Serial No. 1110

TOLEDO EDISON

DAVIS-BESSE NUCLEAR POWER STATION UNIT NO. 1

RESPONSE TO NRC STAFF REQUEST FOR ADDITIONAL INFORMATION

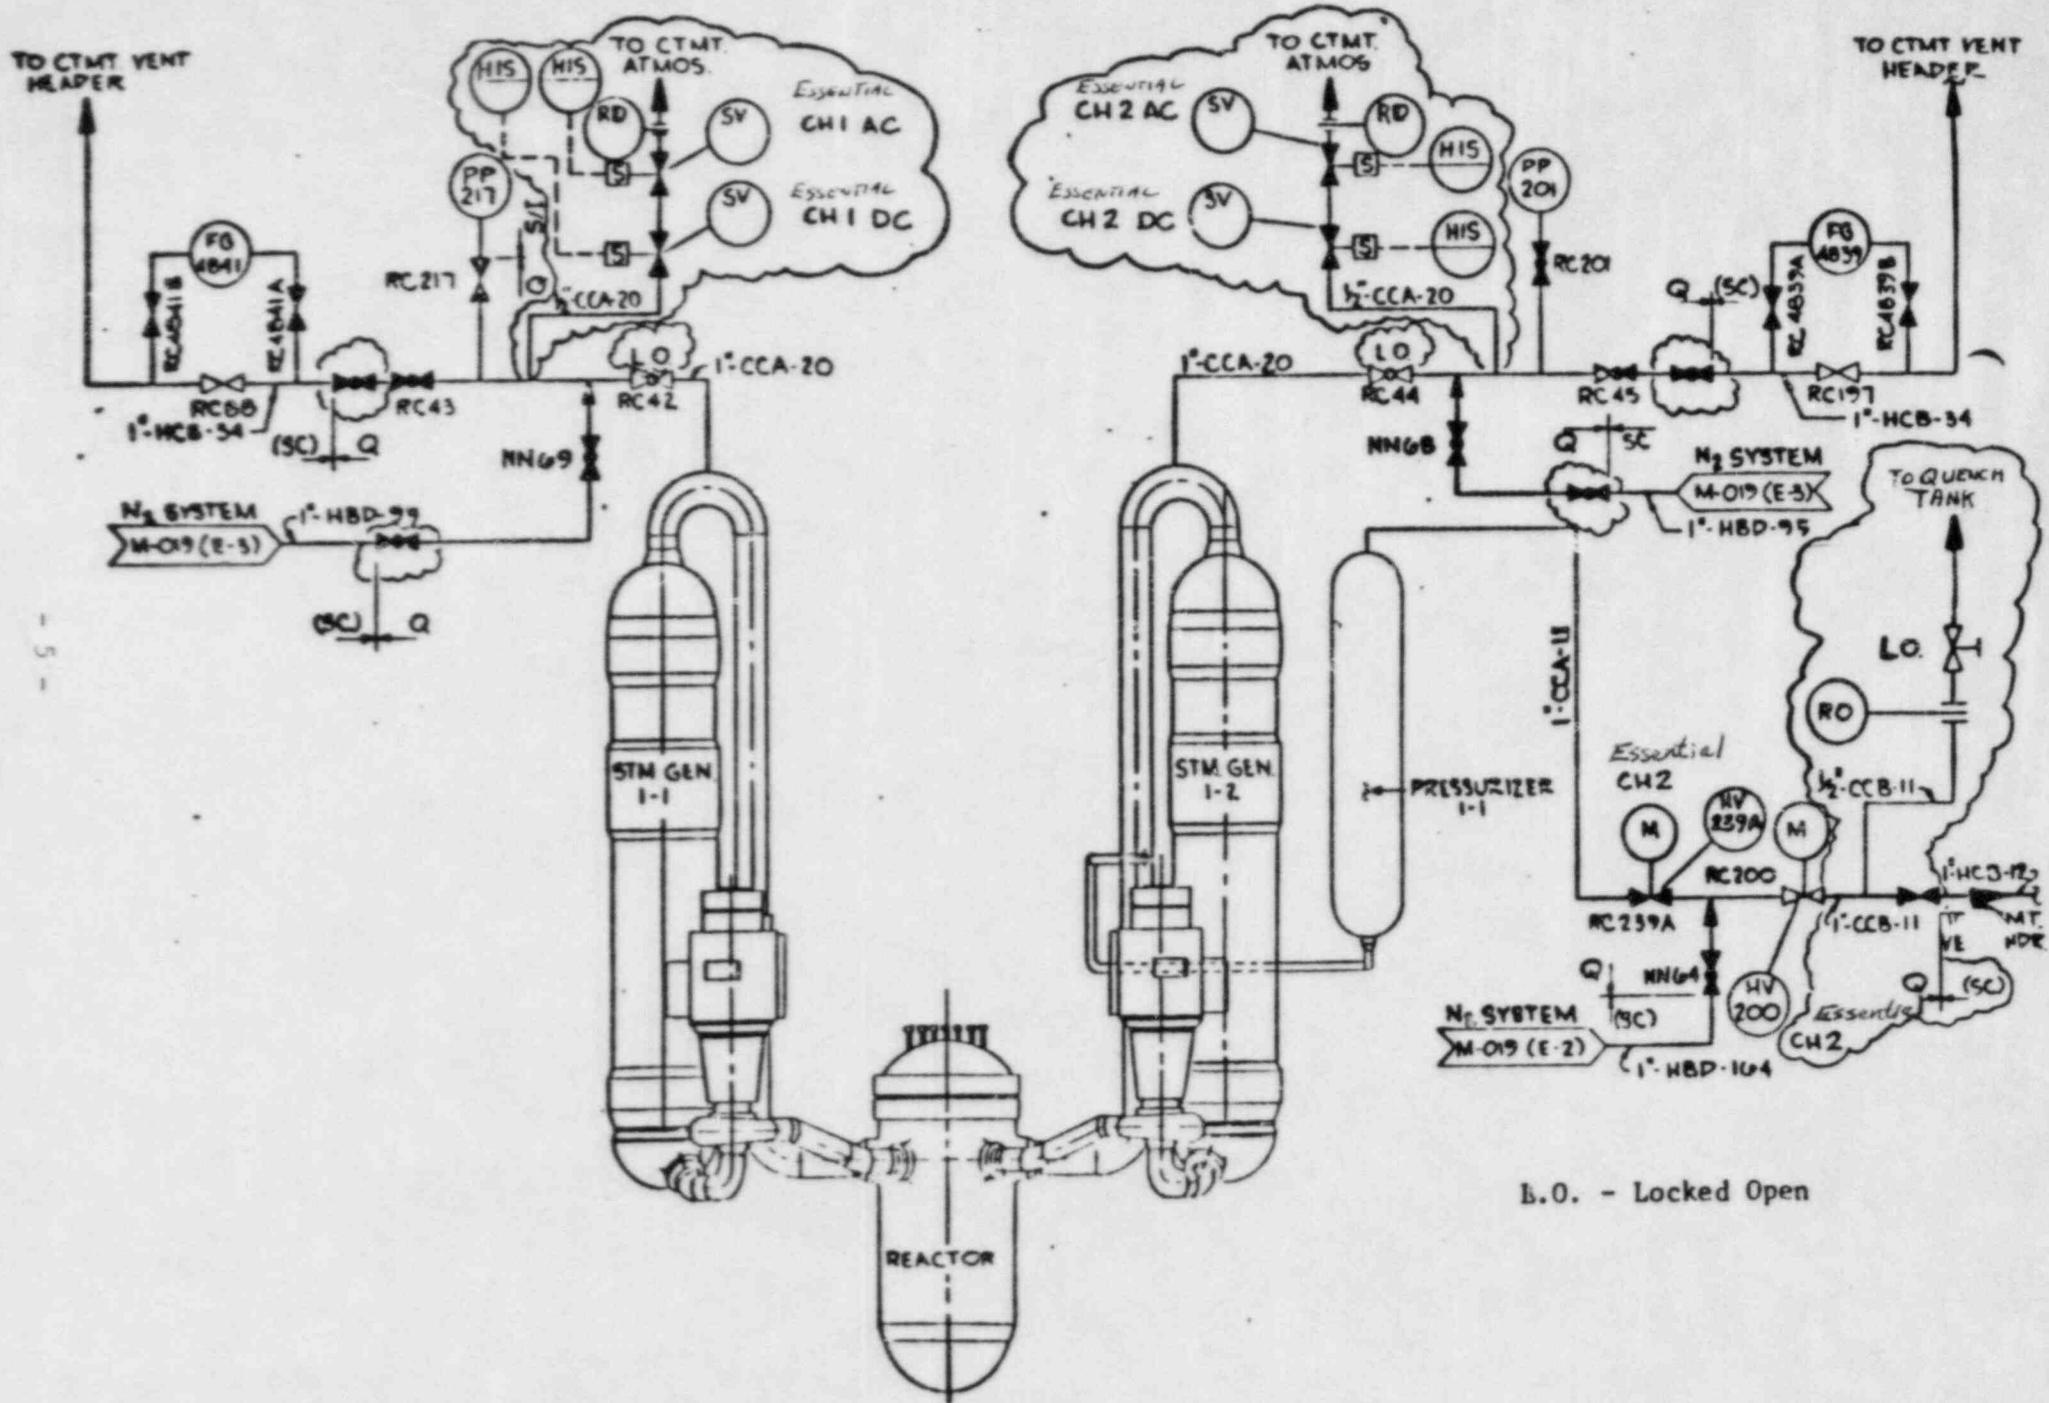
Request No. 4: What is the capability of the RCS hot leg high point vents to blow down the RCS? Provide calculations or testing information supporting the capability of these vents to handle expected flows.

Each of the three high point vents are independently powered by Class 1E sources (see attached diagram) that ensures no single failure results in the loss of more than one high point vent.

2. Demonstrate that the RCS high point vent system (including the pressurizer vent) flow restriction orifices are smaller than the size corresponding to the definition of a loss-of-coolant accident (10 CFR Part 50, Appendix A) by providing the pertinent design parameters of the reactor coolant makeup system and a calculation of the maximum rate of loss of reactor coolant through the RCS high point vent orifices. For those new portions of the RCS high point vent system that are within the LOCA definition (i.e., upstream of the flow restriction orifices), verify that previous analysis or a new analysis has been performed to demonstrate compliance with 10 CFR 50.46 (reference NUREG-0737, Item 11.B.1, Clarification A.(7)). Justify why the flow restriction orifices are not placed upstream of the RCS high point vent valves to limit the amount of new piping that is within the LOCA definition (reference Clarification A.(4)).

In 1 inch schedule 160 pipe, the required flow restriction orifice bore is 0.1927 inches.
